PLANNING COMMITTEE	DATE: 23/03/2015
REPORT OF THE SENIOR PLANNING AND ENVIRONMENT SERVICE MANAGER	CAERNARFON

Application Number: C14/0062/16/LL
Date Registered: 29/01/2014
Application Type: Full - Planning
Community: Llandygai
Ward: Tregarth and Mynydd Llandygai

Proposal: CONVERTING AN EMPTY BUILDING INTO AN AFFORDABLE HOUSE
Location: BRYN LLYWELYN OUTBUILDING, TREGARTH, BANGOR, GWYNEDD, LL574PA

Summary of the Recommendation: TO REFUSE

Job
PROPOSED CONVERSION OF OUTBUILDING INTO A DWELLING AT BRYN LLYWELYN TREGARTH
PLANS AND SECTIONS
Scale: 1:50 Drawing No: 708.1

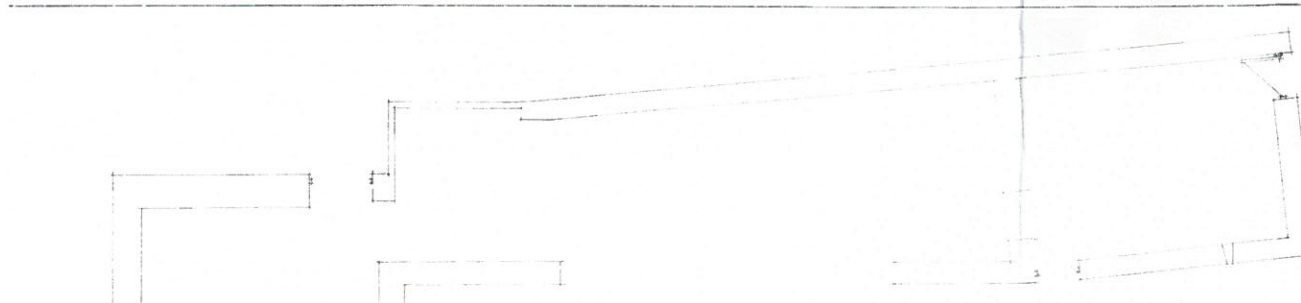
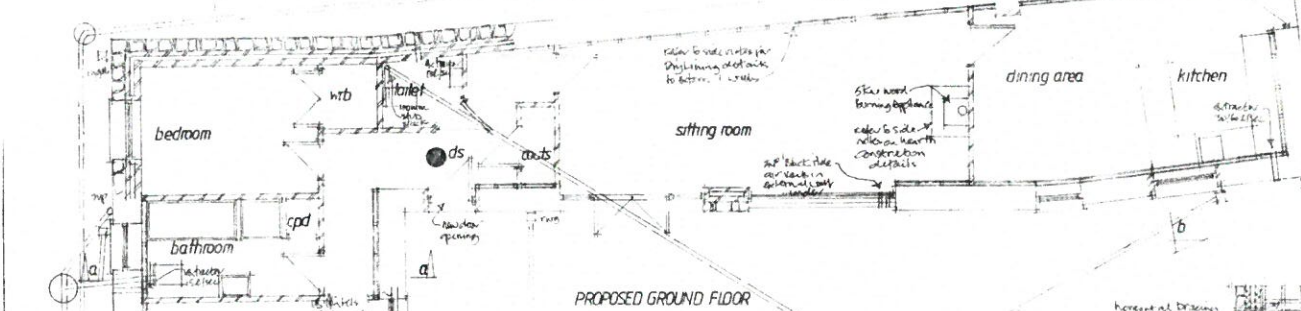
- 1.2 Also, and in response to the concerns noted previously in relation to the size of the proposed extension, the applicant submitted an amended plan which omitted the extension that had originally been proposed for the front of the building. A second full consultation was held following this recent amendment.

- 5.1.8 It is acknowledged that the application has been amended by removing the proposed extension to the front of the building that would make its size excessive in terms of the sizes of affordable units noted in the relevant guidance. Nevertheless, there is also doubt regarding the condition of the building and the extent of the proposed changes and extensions including replacing the existing roofs with pitched roofs and whether or not these would comply with policy C4, requirements of SPG: ‘Converting Buildings in Open Countryside and in Rural Villages’ or the advice provided in TAN 6.

- 5.3.1 There are residential houses located comparatively close to the rear of the buildings. There is some open land between these houses and the site of the application, however, if the proposal was approved it would affect the residents of these houses, compared with what is there at present.
- 5.3.2 Observations were originally received from the residents of the closest property, stating concerns about a window that was to be included on the back wall of the

building. This element was amended by completely removing the window from the proposal. Further observations were received acknowledging that this had satisfied their largest concern, however they have made a request to include conditions that would ensure their privacy and would protect their residential amenities.
